SERVICE BULLETIN

SERVICE BULLETIN		No.: ESB-96E11-502	
		Date: 1997-03-31	<Model> <M/Y>
Subject:	OMISSION OF TIGHTENING TORQUE OF A/C COMPRESSOR TENSION PULLEY FIXING BOLT	CARISMA	96-10
Group:	ENGINE		
Correction	 O. Kai - E.V.P. After Sales Service

This Service Bulletin informs you that omission has been rectified of the tightening torque of A/C compressor tension pulley fixing bolt under Service DRIVE BELT TENSION CHECK AND ADJUSTMENT in Group 11A of the Workshop Manual.

FUEL TANK

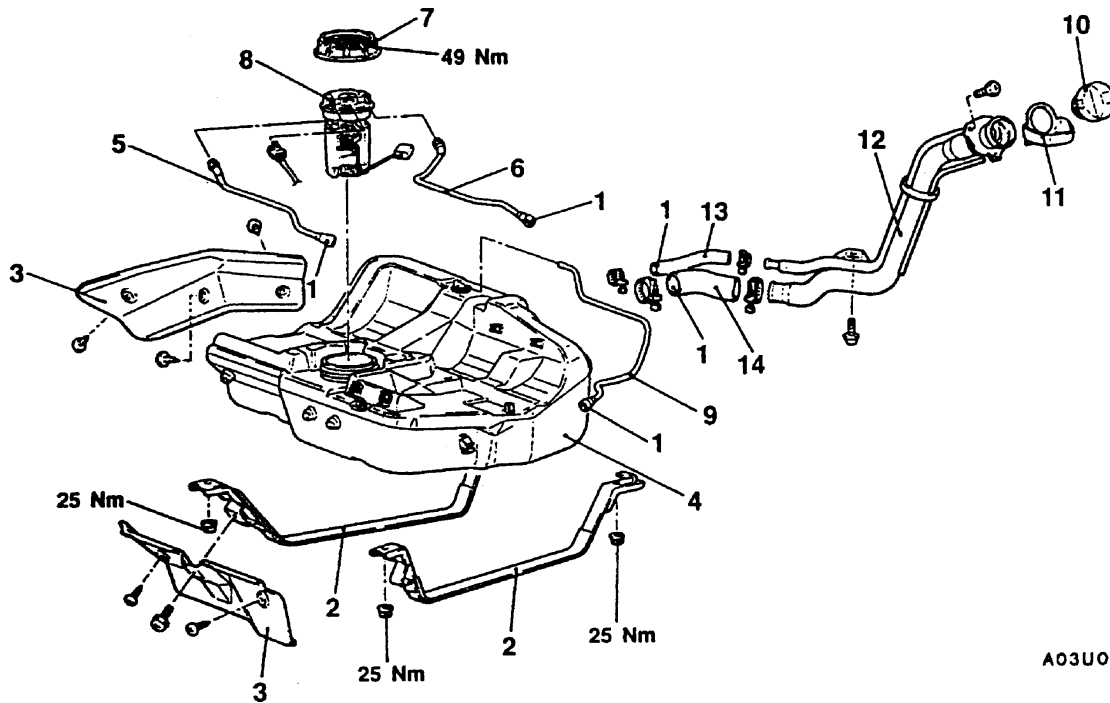
<Added>

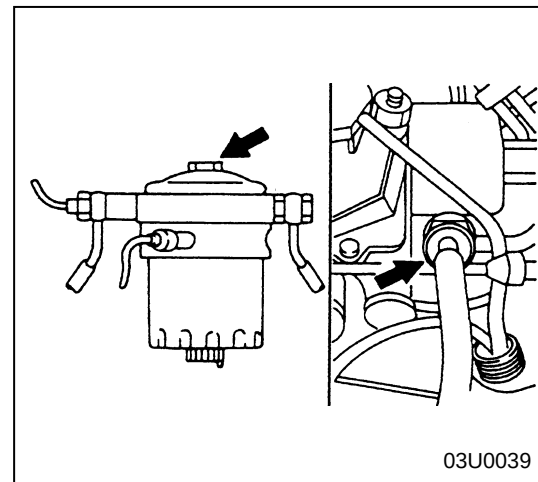
<Correct>

2. Place a drainage tray under the filter.
3. Connect a hose to the drain plug and let it hang down into the tray.
4. Open the fuel pump air plug.
5. Loosen the drain plug a few turns and tighten the drain plug when clean fuel comes through.
6. Bleed the air.

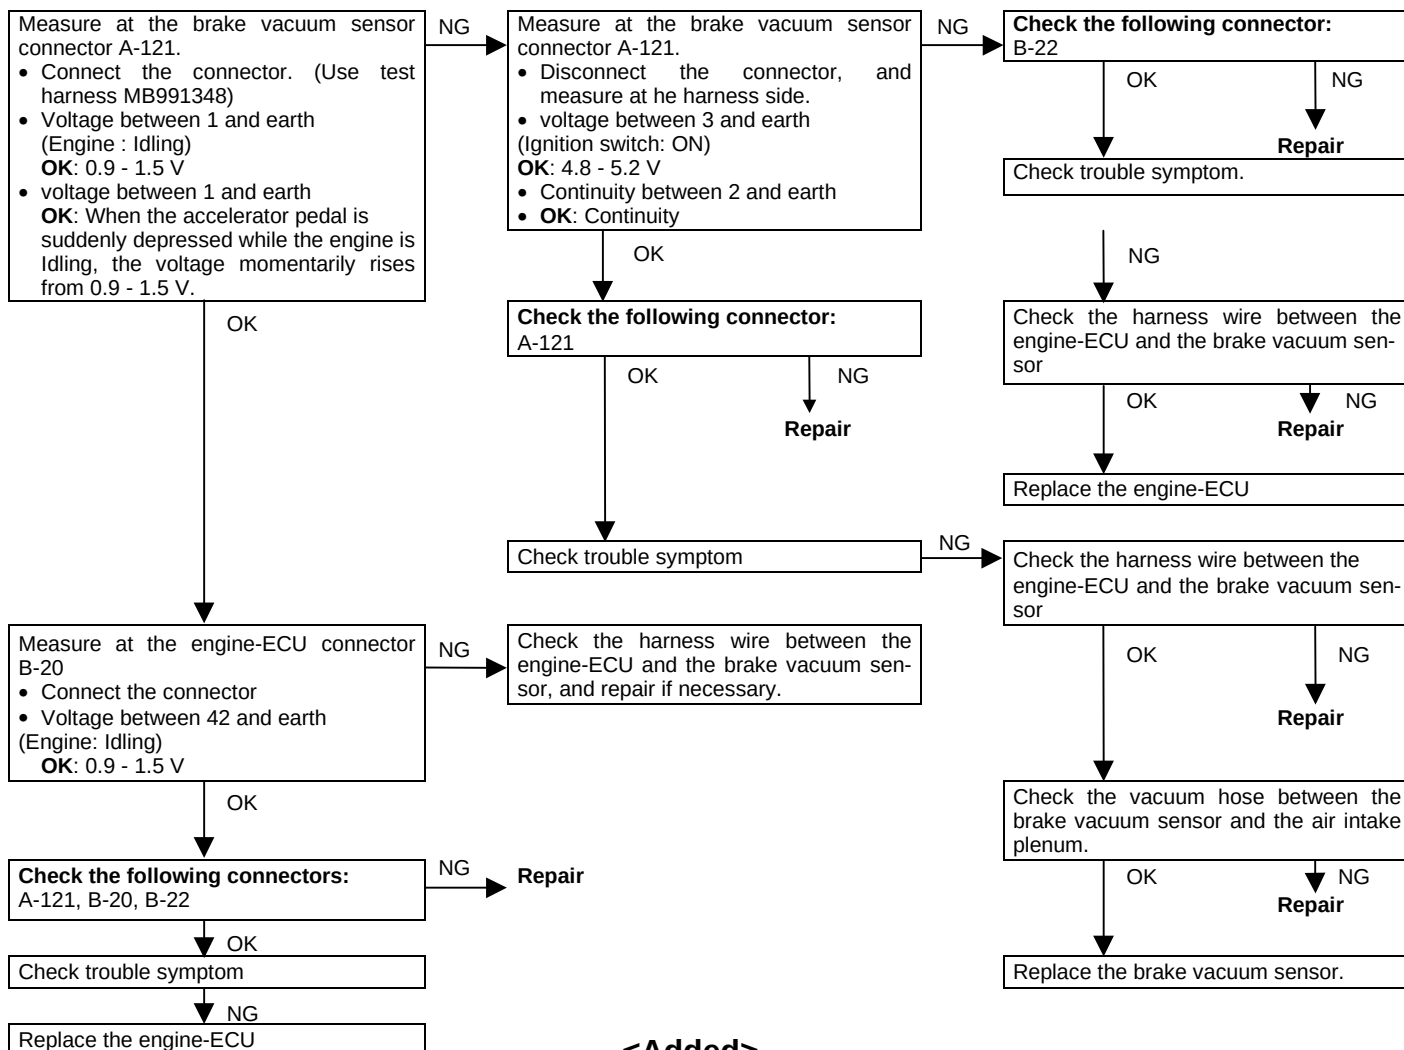
↑
<Added>

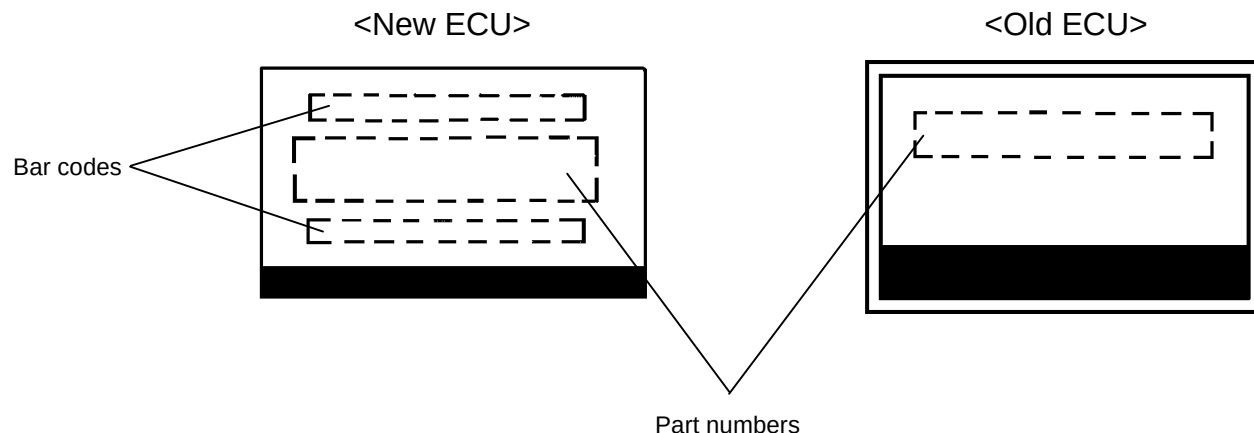
Due to change of the cruise control ECU, the battery back-up circuit inside the ECU has been eliminated and the EEP ROM adopted. This resulted in change of the erasing method for diagnostic trouble codes.

New ECU	Old ECU
New car	○	▲
Old car	○	○

▲: Can be installed if car has a battery back-up wire added on the chassis side harness.

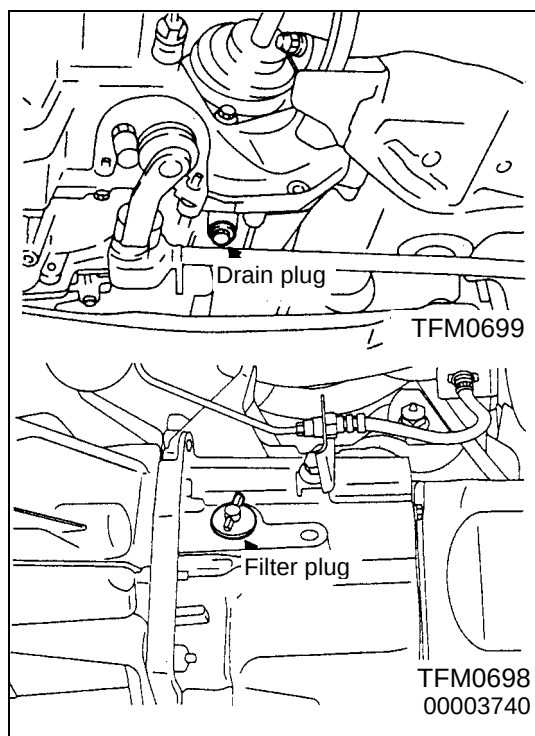
3. ~~Tighten filler plug to specified torque.~~ **<Incorrect>**

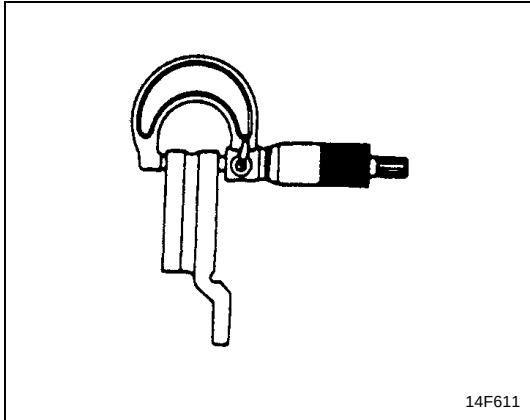
<New>

0.07 or less <Up to June 1997>
0.06 or less <From July 1997>

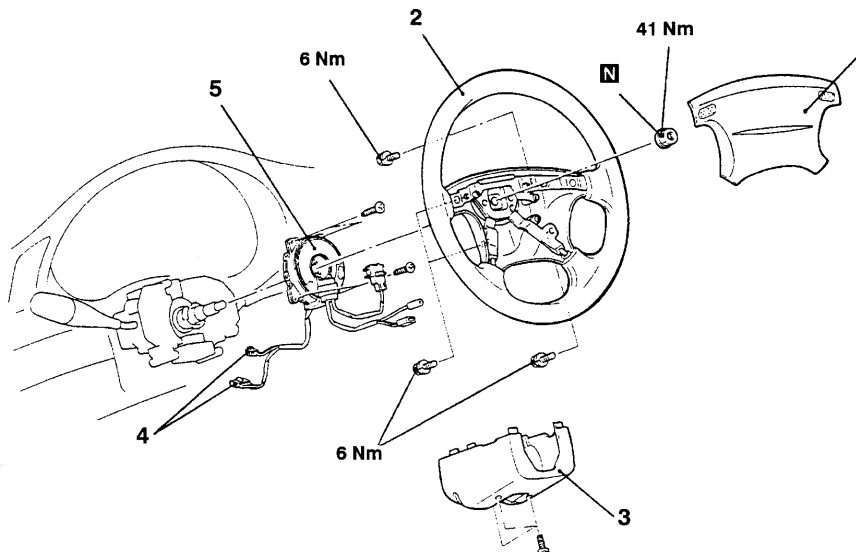
6. **After deployment of an air bag, replace the clock spring.**

After deployment of an air bag, replace the air bag modules. Check the clock spring, and if faulty, replace it with a new part.

Code No. 56 Fuel pressure sensor system**Probable cause**

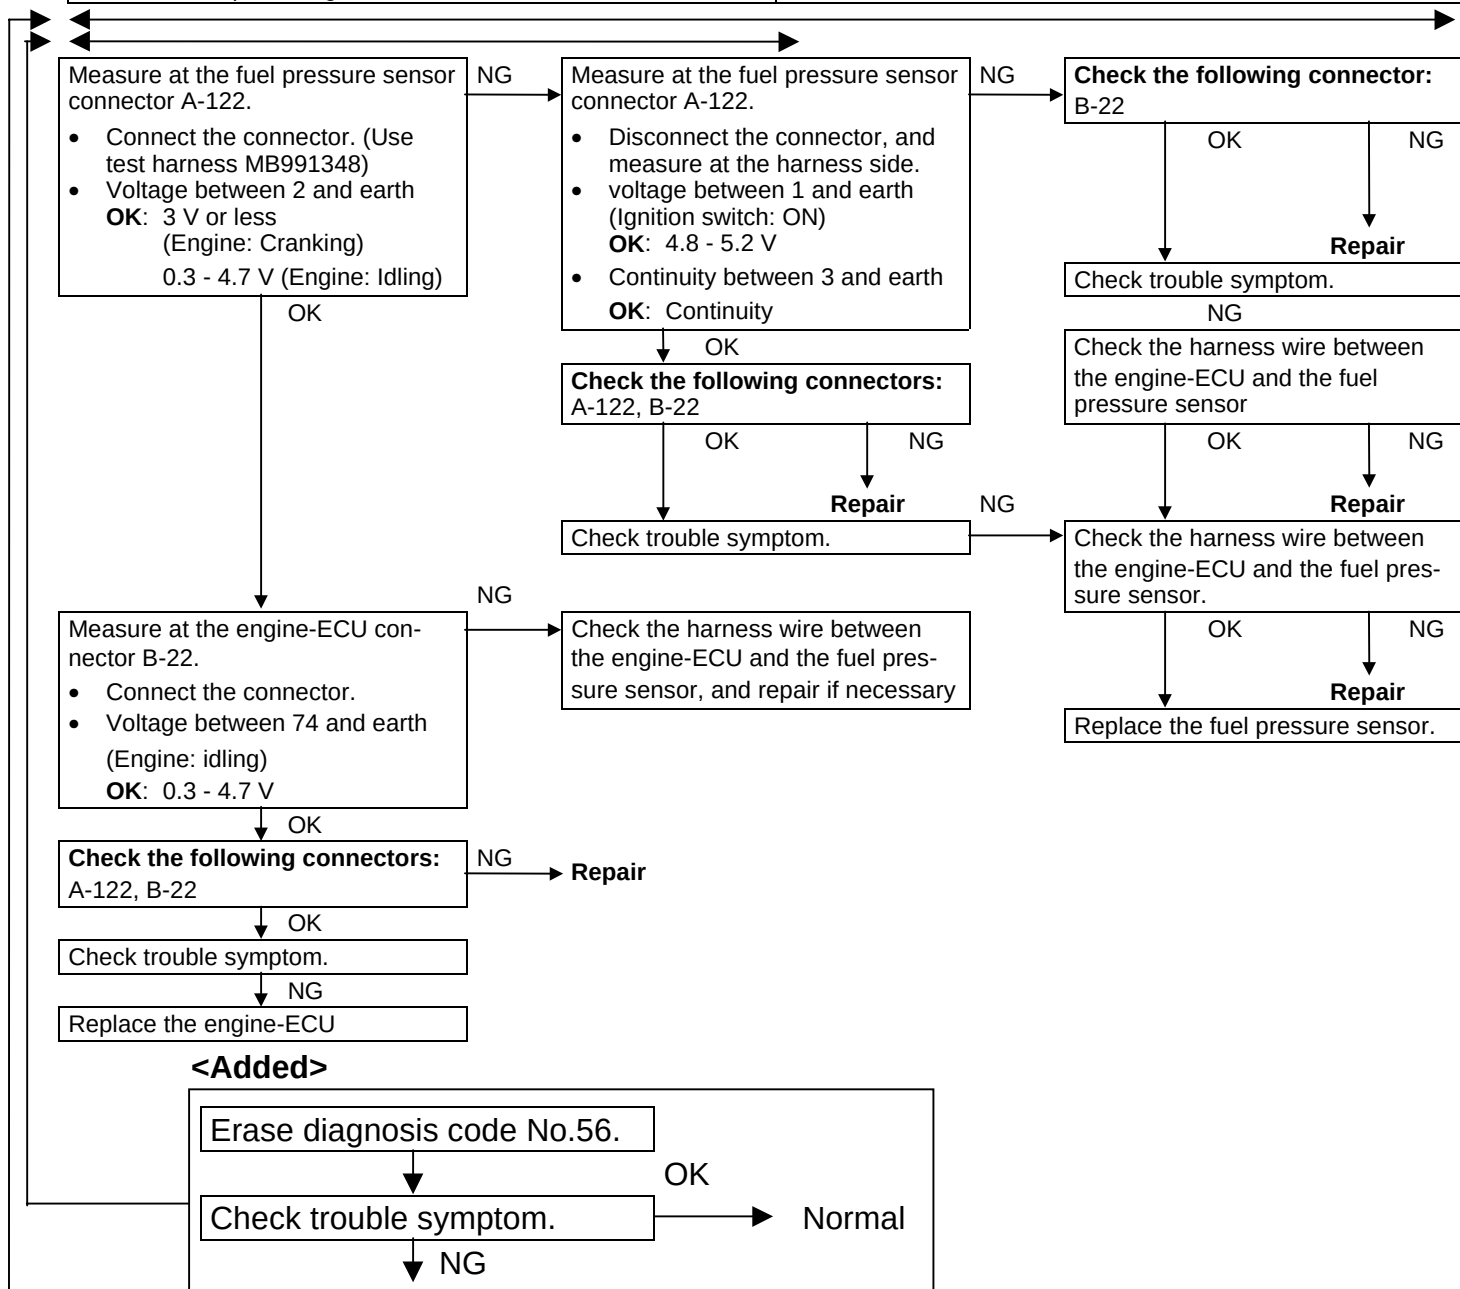
<Added>
